**SUBJECT:** NuScale Power, LLC Supplemental Response to NRC Request for Additional Information No. 196 (eRAI No. 9050) on the NuScale Design Certification Application

NuScale Supplemental Response to NRC Request for Additional Information eRAI No. 9050

### **NRC Question No.:** 16-18

Figure 7.1-1k: ESFAS - Containment System Isolation, Chemical and Volume Control System Interlocks

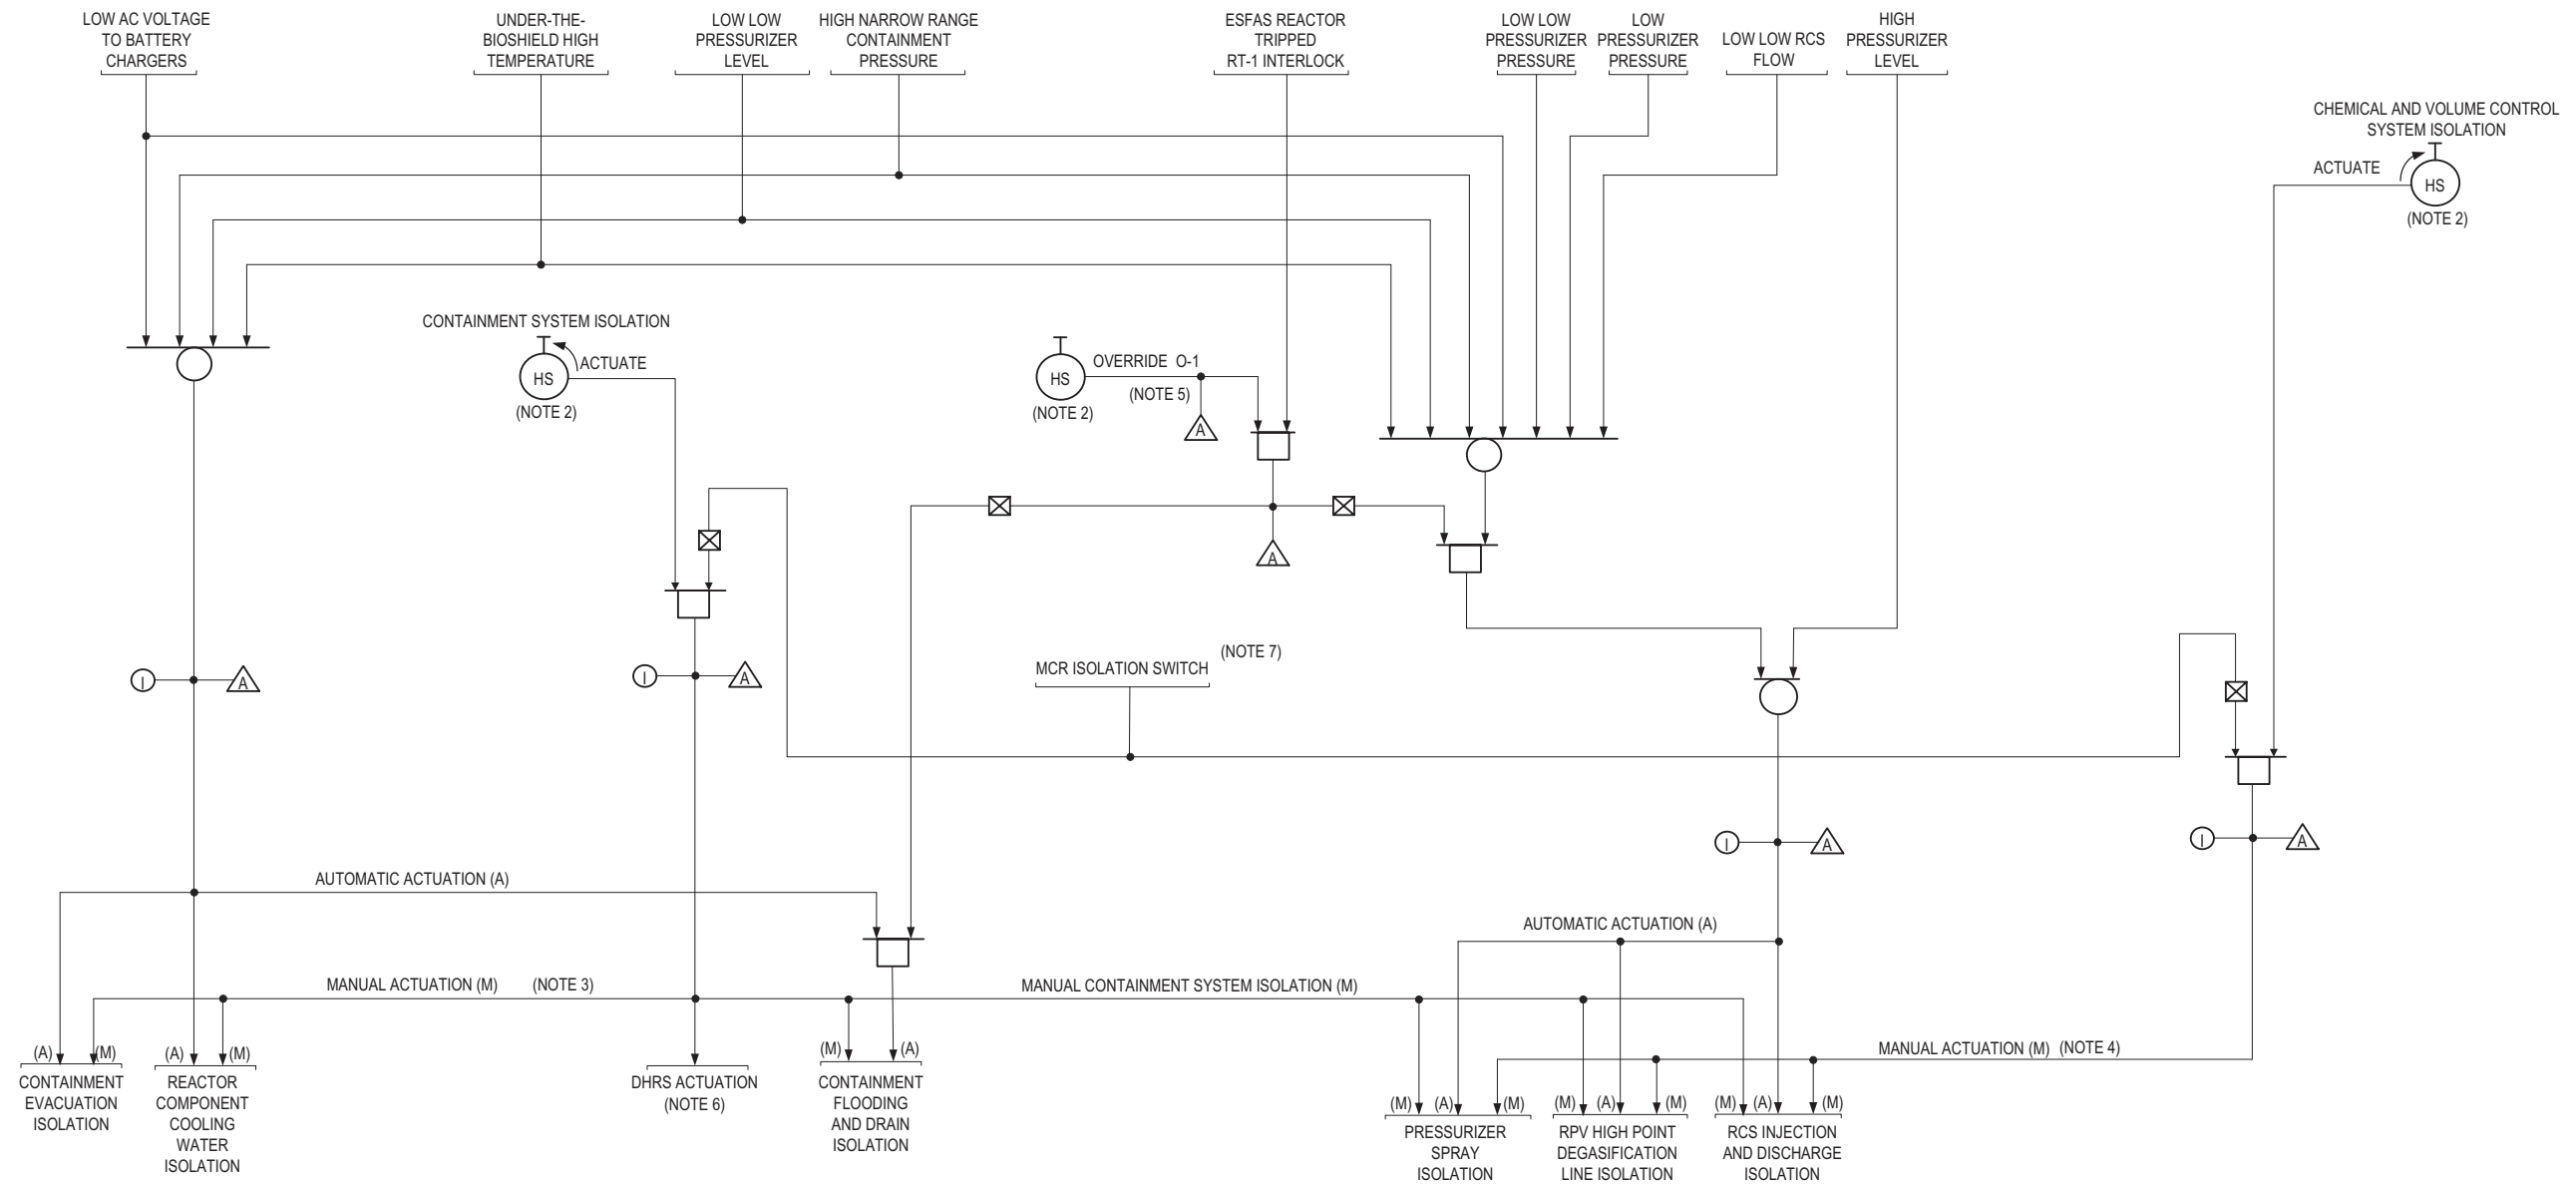
- a. Clarify in Subsections B 3.3.1, B 3.3.2, and B 3.3.3 that the interlocks and permissives associated with each MODULE Protection System (MPS) Instrumentation Function channel, each Reactor Trip System (RTS) Logic and Actuation Function division, and each Engineered Safety Features Actuation System (ESFAS) Logic and Actuation Function division, respectively, must be OPERABLE for the associated Function channel or Function division to be OPERABLE.

- d. Clarify in Subsection B 3.3.3 that the required interlocks and permissives are verified to be OPERABLE by the ACTUATION LOGIC TEST specified by SR 3.3.3.1 for each associated ESFAS Logic and Actuation Function division.

A description of the O-1 override is added to the Bases of LCO 3.3.1. The override applies to

portions of the MPS and actuations described in LCO 3.3.3, however no additional changes are proposed because those Bases refer to the description provided in the Bases for LCO 3.3.1. Additionally, some changes were made to Chapter 7, "Instrumentation and Controls," Table 7.1-5, "Module Protection System Interlocks / Permissives / Overrides," and Figure 7.1-1k, "ESFAS - Containment System Isolation, Chemical and Volume Control System Interlocks," of the FSAR to describe the design and function of the O-1 override.
